Dwelling type:	House and Garage.
Dwelling configuration:	Single Storey.
Nature of works:	New Building.
Stage of inspection:	Pre Pour.
Construction Type:	Brick Veneer.
Garage:	Attached.
Foundations:	Slab.
Builder:

Schedule of Defects:

Defects, observations and other related comments from the Pre Pour Inspection on the 27/04/2021:

FIGURE 3.4 (in part) WAFFLE RAFT

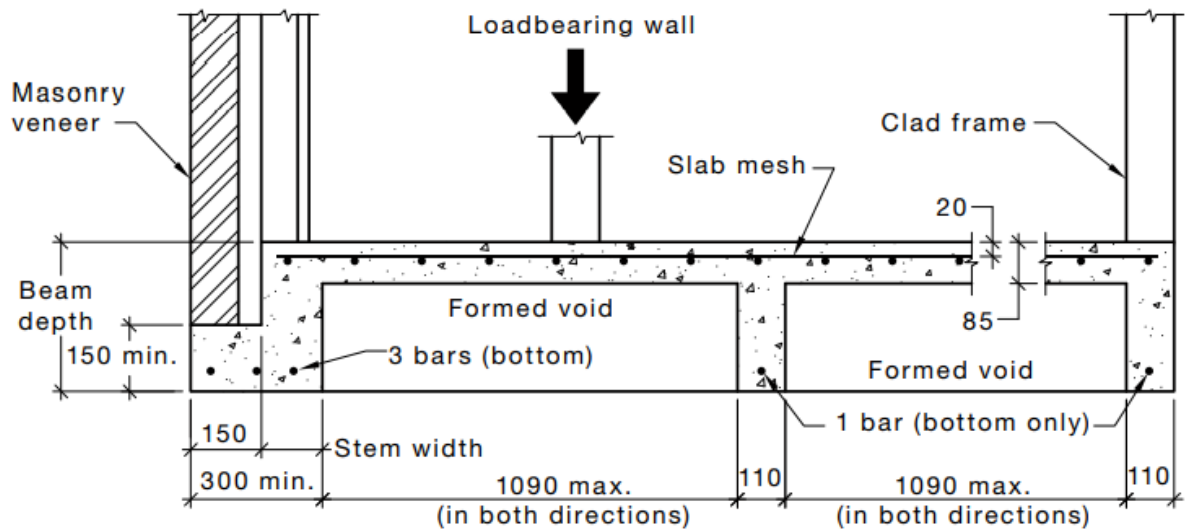
AS 2870; 3.4.3: - Pods have been deleted resulting in widening of the designed beam width. The missing pods need to be installed or additional reinforcing bars are required to be installed in accordance with the following.

The current installation does not meet this requirement.

3.4.3 Reinforcement

Additional reinforcement shall be provided for all beams where the stem width exceeds 150 mm. The size and specification of top bars shall be the same as bottom bars except as specified in Figure 3.4. The total number of reinforcement bars in beams shall be as follows:

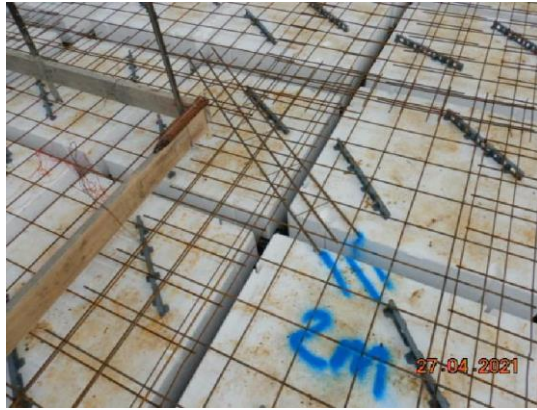
NCC 2019, 3.2.3.2 (d): - Pod debris and steel offcuts can potentially compromise the minimum concrete cover to reinforcement. The minimum distance from the outer edge of reinforcement bars to an internal surface is 20mm.

This dwelling's ribs and edge beams contain excessive amounts pod debris and / or steel offcuts.

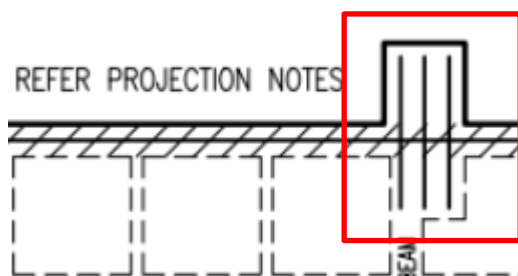
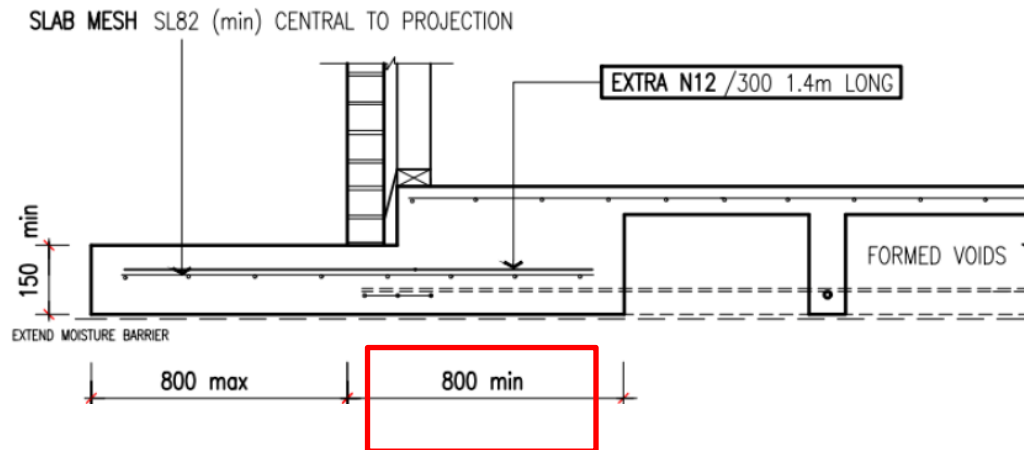
It was noted the HWS pad has not presented as per supplied engineering. Refer to the engineering extract below.

Cut pod

Slab mesh to project into main slab
800mm

Install bars as per detail

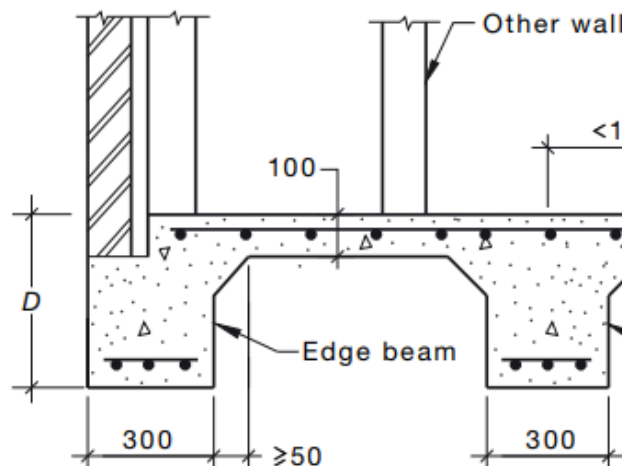
The sagging mesh noted to the external corners of the dwelling shows that this requirement has not been met.

Supports for fabric reinforcement are provided to prevent the fabric distorting when workers walk on top of it to place the concrete and maintain the correct concrete cover to the fabric.

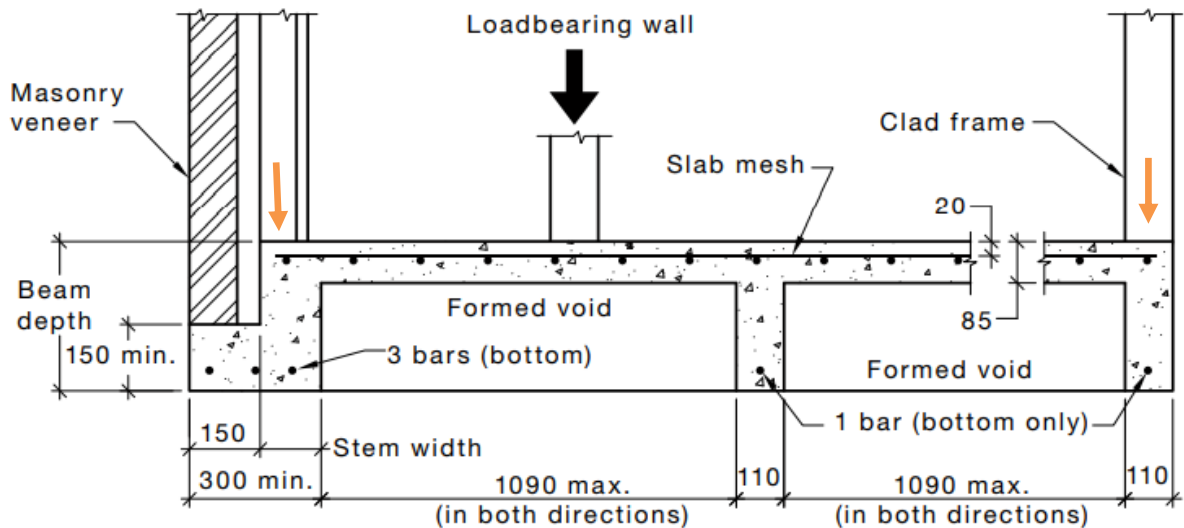
AS 2870; 5.6.4, 6.6 & C5.6.4: - All sewer connections running through beams or footings must be fully lagged in accordance with the soil rating.

Plumbing drainage to this dwelling has not met this requirement.

Closed-cell polyethylene lagging shall be used around all stormwater and sanitary plumbing drain pipe penetrations through footings. The lagging shall be a minimum of 20 mm thick on Class H1 sites and 40 mm thick on Class H2 and Class E sites. Vertical penetrations do not require lagging.

Drains that pass through footings are required to be wrapped with closed cell foam so as to allow movement between the pipe and the footing. Particular care and vigilance is required to ensure that the lagging is arranged to ensure that concrete, as it is poured, cannot creep around the ends of the lagged section and thereby form a close fitting collar around the pipe, which defeats the purpose of the lagging.

DETAIL FOR PLUMBING PENETRATION IN BEAM

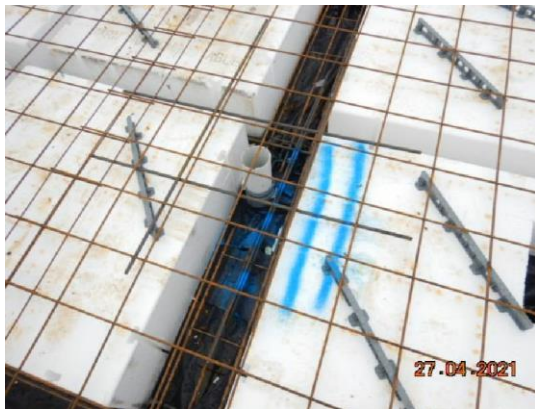
It was noted the deleted bars have not been installed as per the detail below. Furthermore the bars are to be separated. Refer to the extract below.

ADDITIONAL N12 BAR TO BOTTOM
ADDITIONAL N12 BAR TO TOP (U/S OF MESH)

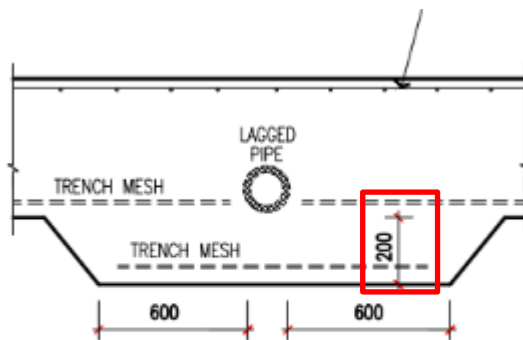
It was noted the trench mesh has not been installed with the required 200mm separation to the underside of the pipe. Refer to extract below.

PIPE THROUGH PERIMETER BEAM MINIMUM 40mm LAGGING - ENSURE NO GAPS
